Service Bulletin

PRELIMINARY INFORMATION

Subject: Poor Radio Hands-free Voice Recognition Performance or Sound Quality After OnStar Upgrade

Models: 2008-2015 Buick Enclave
 2012 Buick Verano
 2006-2011 Cadillac DTS
 2007-2009 Cadillac SRX
 2007-2013 Cadillac Escalade
 2008-2015 Cadillac CTS
 2007-2013 Chevrolet Avalanche, Silverado, Suburban, Tahoe
 2007-2013 GMC Denali, Sierra, Yukon
 2007-2015 GMC Acadia
 2007-2010 Saturn OUTLOOK

Repair 1 - OnStar Module, Relocate the Microphone and Ground Circuits from X3 to X2 Connector

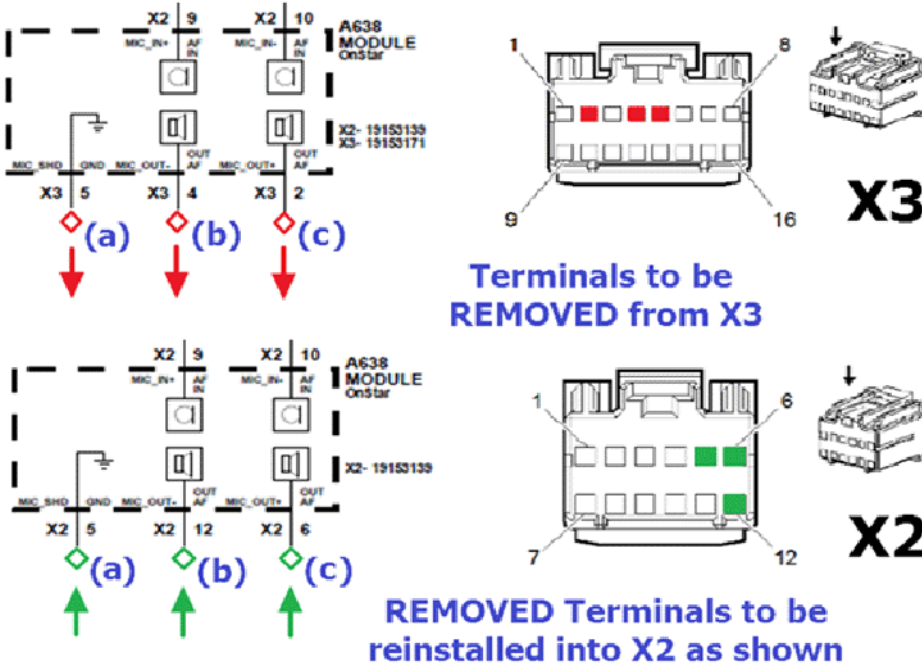
Note: Repair 1 is not needed if the VCIM part number is 84021666 or 84021667.

- a: Move terminal 5 on X3 to terminal 5 on X2.
- b: Move terminal 4 on X3 to terminal 12 on X2.
- c: Move terminal 2 on X3 to terminal 6 on X2.

- (a) Move terminal 5 on X3 to terminal 5 on X2
- (b) Move terminal 4 on X3 to terminal 12 on X2
- (c) Move terminal 2 on X3 to terminal 6 on X2

Repair 2 - OnStar Module, Pin 12 on X2 Connector Ground Instructions

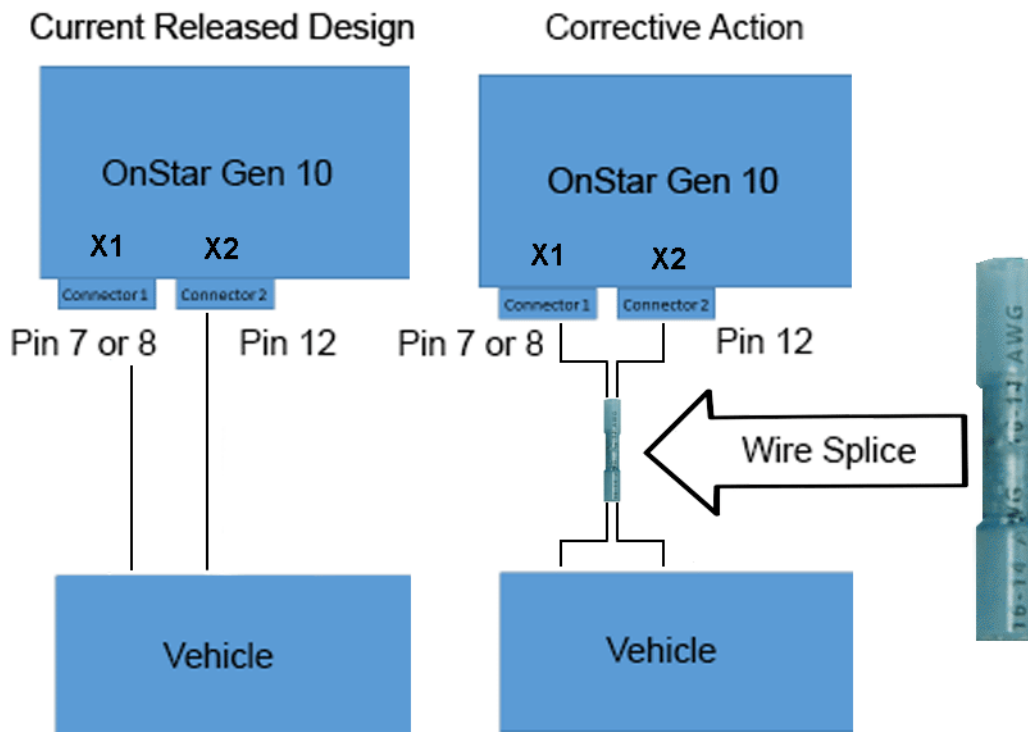
Ground pin 12 of X2 connector by splicing Pin 12 to X1 Pin 7 or 8.

Install a blue Duraseal splice connector to the wires, (P/N 19168447, from the J-38125 Terminal Repair Kit).

Note: To determine whether splicing will take place at Pin 7 or 8 of (X1) connector 1, the technician will need to visually check existing terminal location. (Location varies based on harness build).
